| IN THE MATTER OF THE REVISIONS TO |) |
|---|---|
| TITLE V OPERATING PERMIT NO. O-0127-16-V FOR |) |
| MILL CREEK GENERATING STATION |) |

SIERRA CLUB'S PETITION TO THE EPA ADMINISTRATOR TO OBJECT TO ISSUANCE OF THE REVISED TITLE V OPERATING PERMIT FOR THE MILL CREEK POWER PLANT IN LOUISVILLE, KENTUCKY

<u>Figure 1</u>: Mill Creek Hourly & 30-Day Rolling Avg. SO₂ Emissions (lb/MMBtu): 2016 Historic Rates¹² Compared to Revised/Proposed Permit Limit

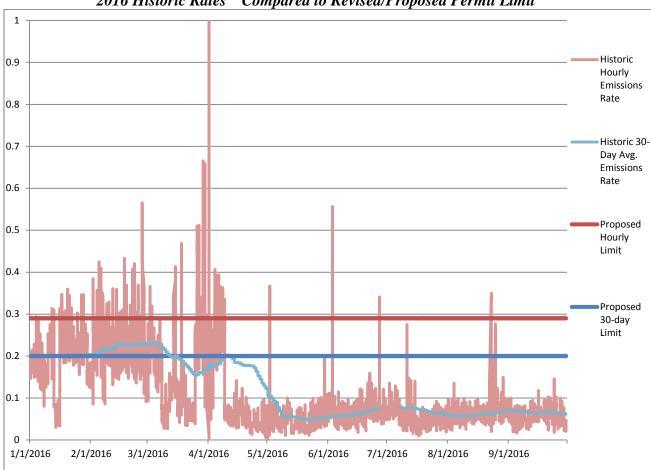
Moreover and in any event, a visual depiction of Mill Creek's recent SO_2 emissions starkly illustrates the inability of a 720-hour rolling-average limit to ensure that the critically protective 1-hour NAAQS is met there. As seen in Figure 1, below, 720-hour averaging effectively smooths out instances of excessive 1-hour emissions, which are relatively frequent and substantial at Mill Creek, and results in fewer and less significant exceedances of the 720-hour limit as compared to the 1-hour standard. If enshrined as a permit condition, that method would thus purport to allow Mill Creek to emit unlawful, health-jeopardizing levels of SO_2 more often and more drastically.

Mill Creek's actual hourly emissions (depicted in pink) frequently exceed the 0.29 lb/MMBtu 1-hour emissions standard on which LG&E based its 720-hour conversion 13 (the red

line)—indeed, 340 distinct times (*i.e.*, reporting hours) over the course of the first nine months of 2016—and sometimes by an enormous degree. By contrast, Mill Creek's rolling 30-day average (the turquoise line) exceeded the proposed 0.20 lb/MMBtu 720-hour standard (the blue line) in the Revised Permit far fewer times—fewer than 45 times (*i.e.*, reporting days) over the calculable stretch of eight months—and with much less severity.

The smoothing-out effect inherent to long-term averaging at a plant with substantially variable emissions, like Mill Creek, masks significant hours in which emissions are above safe, lawful levels. Thus, not only would the 720-hour standard effectively allow LG&E to escape otherwise applicable legal liabilities under the NAAQS, but would also pose serious public health risks—keeping in mind that the adverse effects of excessively emitted SO₂ can be caused by exposures as brief as *five minutes*.
